Addendum 1

October 30, 2017

Energy Plant Repairs and Modifications
University of South Carolina
State Project Number: H27-Z215

1 WEST ENERGY FACILITY BASEMENT ELECTRICAL PLAN
SCALE: 1/8" = 1'-0"

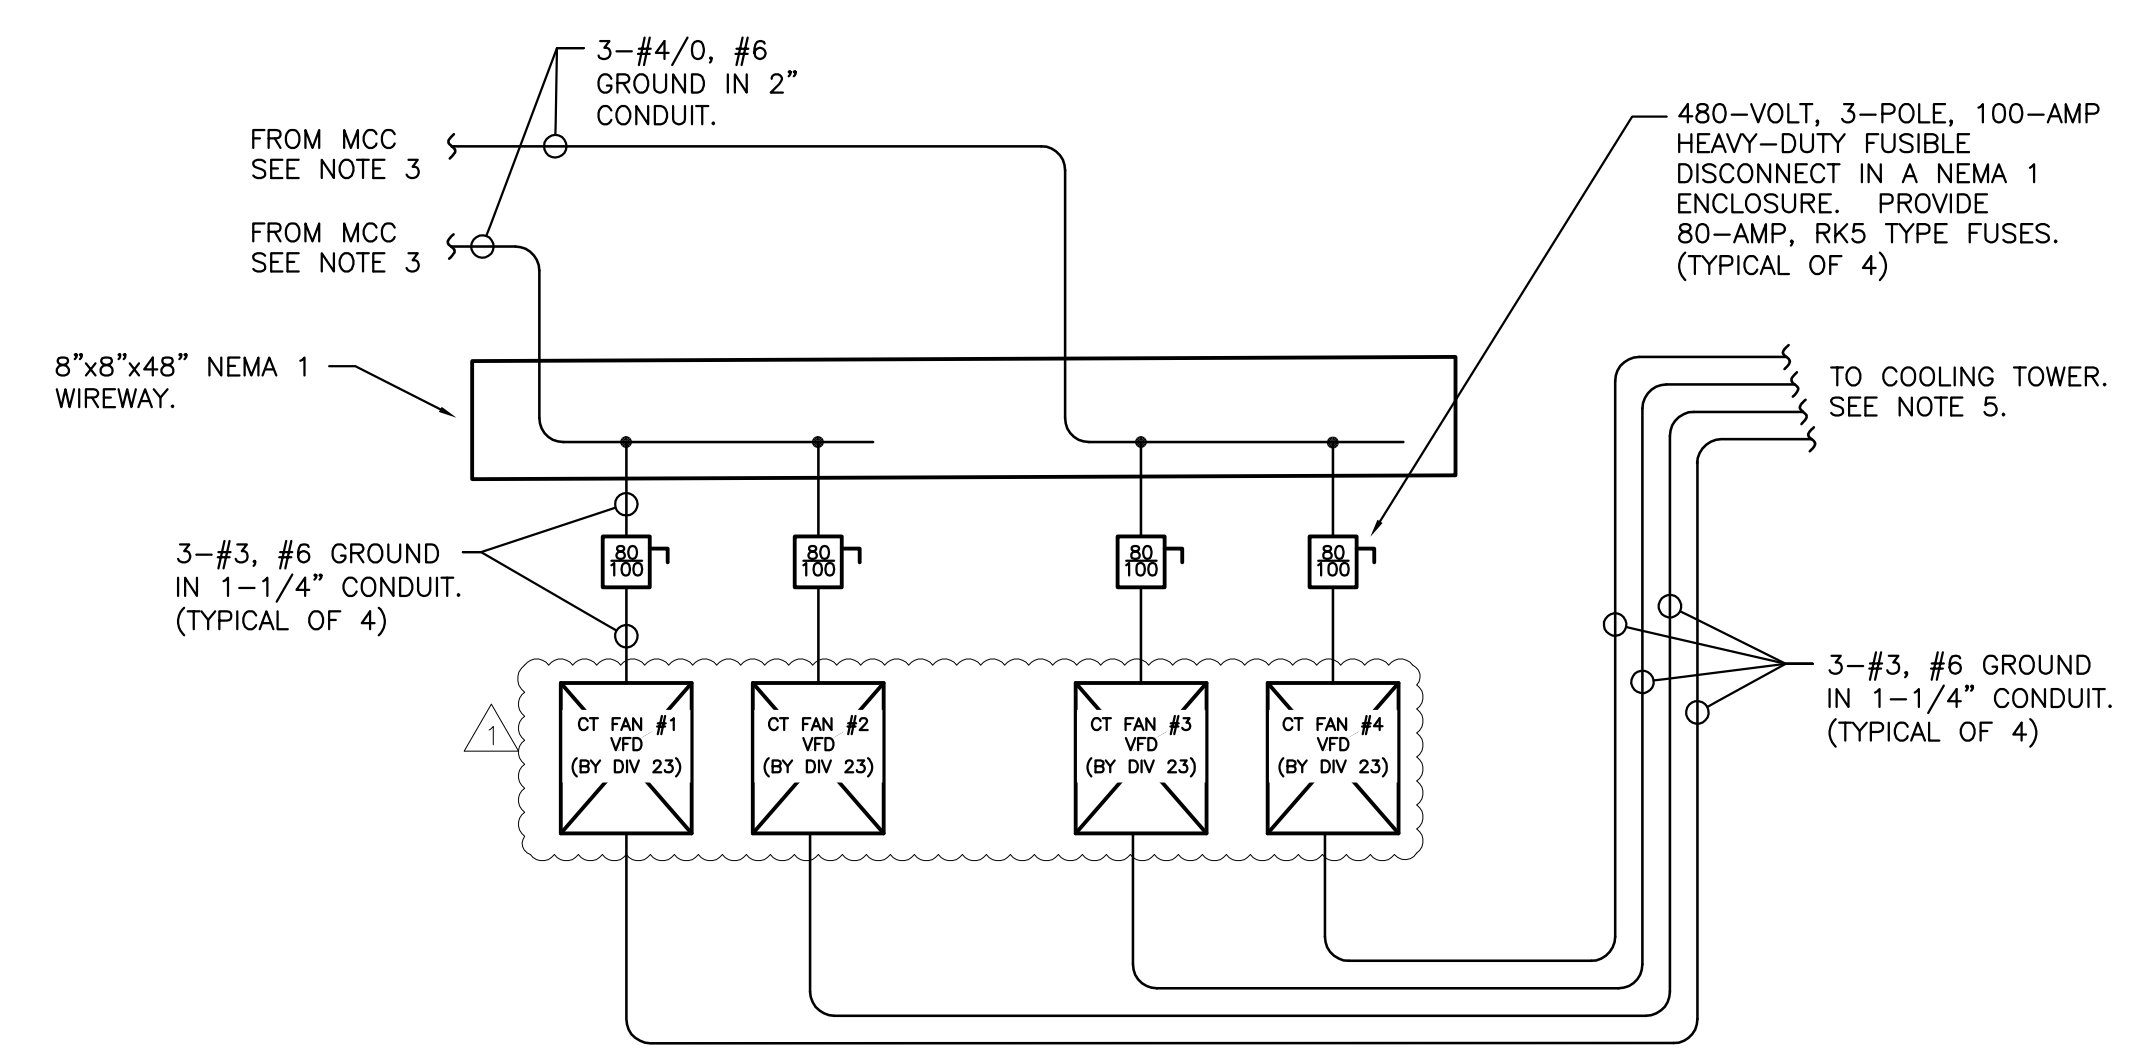
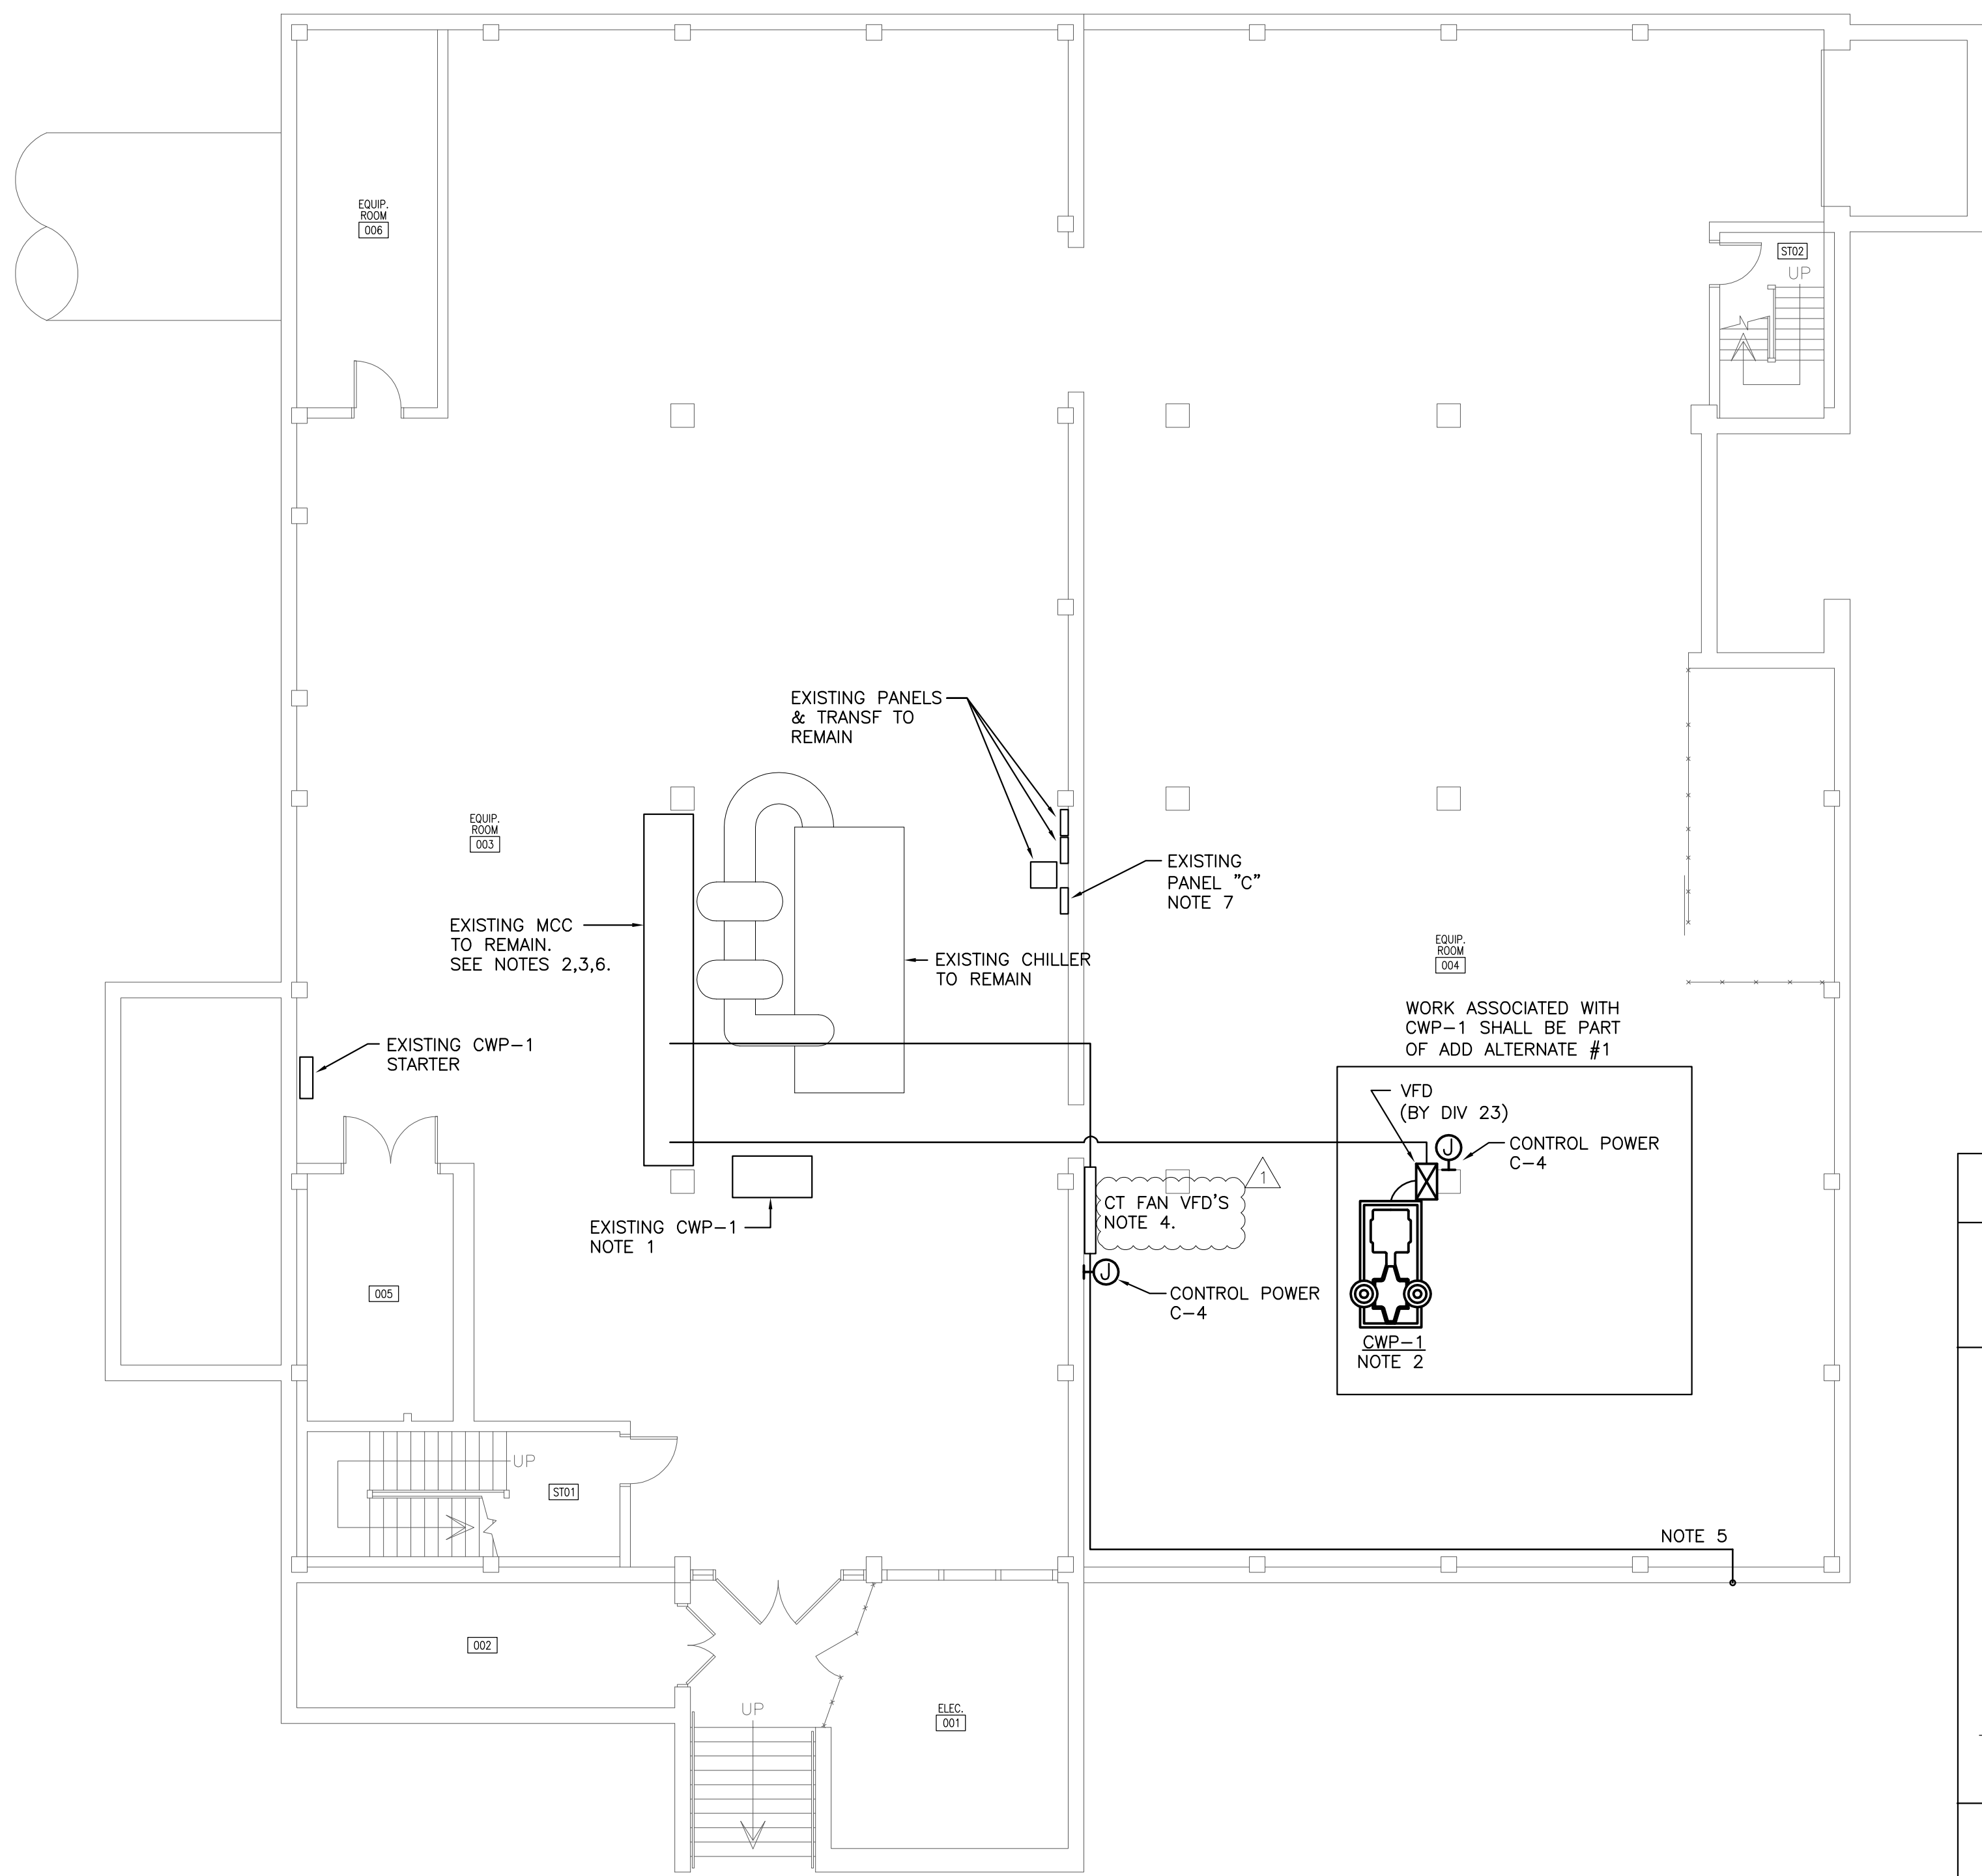
| 5. | <u>Clarification:</u> The tower fan motor variable frequency drives are located inside per drawing E2. |

5. Revision: Reference Drawing E2 West Energy Facility Basement Electrical Plan. Change description of mechanical controls for CT fans from starters to VFD's.

- PROVIDE WIREWAY AND FUSED DISCONNECTS AT LOCATION OF COOLING TOWER FAN VFD'S. SEE DETAIL 3 / E2 FOR ADDITIONAL INFORMATION.
- ROUTE RACEWAYS FROM STARTERS (FANS) AND MCC (HEATERS) TO COOLING TOWER. ROUTE OVERHEAD IN BASEMENT AS MUCH AS PRACTICAL AND PENETRATE EXTERIOR WALL BELOW GRADE AND EXTEND TO COOLING TOWER. SEE ELECTRICAL SITE PLAN ON SHEET E1 FOR ADDITIONAL INFORMATION.
